**SECTION 4.55(1A) MODIFICATION APPLICATION – SSD 9670 MOD 5  
WESTERN SYDNEY UNIVERSITY INNOVATION HUB – 2-6 HASSALL STREET, PARRAMATTA**

This application is the fifth modification to the consent and is known as MOD 5. The application proposes to amend Condition A2 in relation to minor adjustments to the location and dimensions of the northern and western signage zones in order to accommodate the final design of the Western Sydney University building identification signage. This signage is proposed to be installed in accordance with Condition A29.

**Figure 2 Proposed Signage Zone – Northern Elevation**

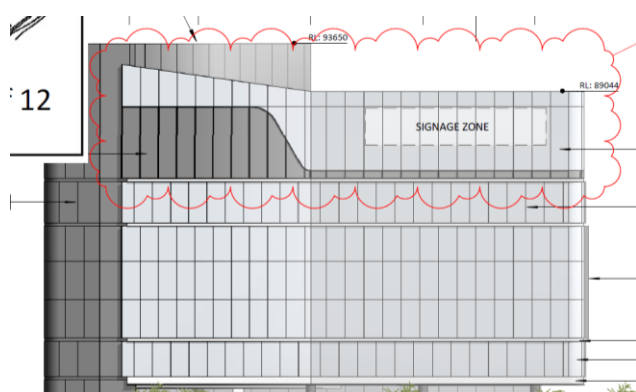
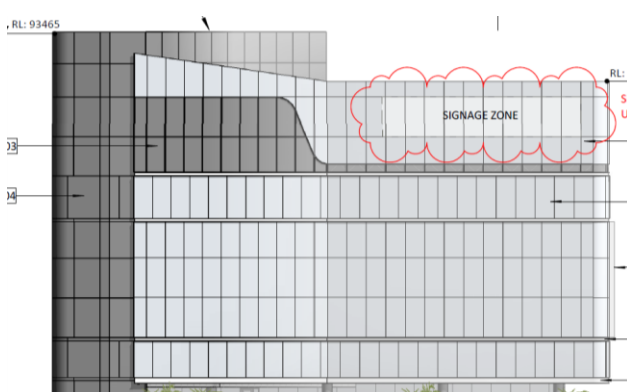
The proposed modification to development consent SSD 9670 seeks to make minor adjustments to the dimensions of two (2) signage zones, being:

- One (1) on the Northern Elevation within the building parapet; and
- One (1) on the Western Elevation within the building parapet.

These signage zones are required to be amended in order to accommodate the final design of the Western Sydney University building identification signage.

The proposed modification involves adjustments to the approved signage zones on the north and west elevations to accommodate the final design of the Western Sydney University building identification signage, which are proposed to be installed in accordance with Condition A29. The proposed modifications are minor in nature, as shown in the comparison of the approved signage zones and the proposed signage zones (provided in **Figure 1** to **Figure 4** below).

Architectural Plans prepared by Tzannes Blight Rayner			
Dwg No.	Rev	Name of Plan	Date
30.00	<del>LO</del>	North Elevation	<del>09.08.2019</del> <b><i>10.12.2020</i></b>
30.03	<del>LO</del>	West Elevation	<del>09.08.2019</del> <b><i>10.12.2020</i></b>
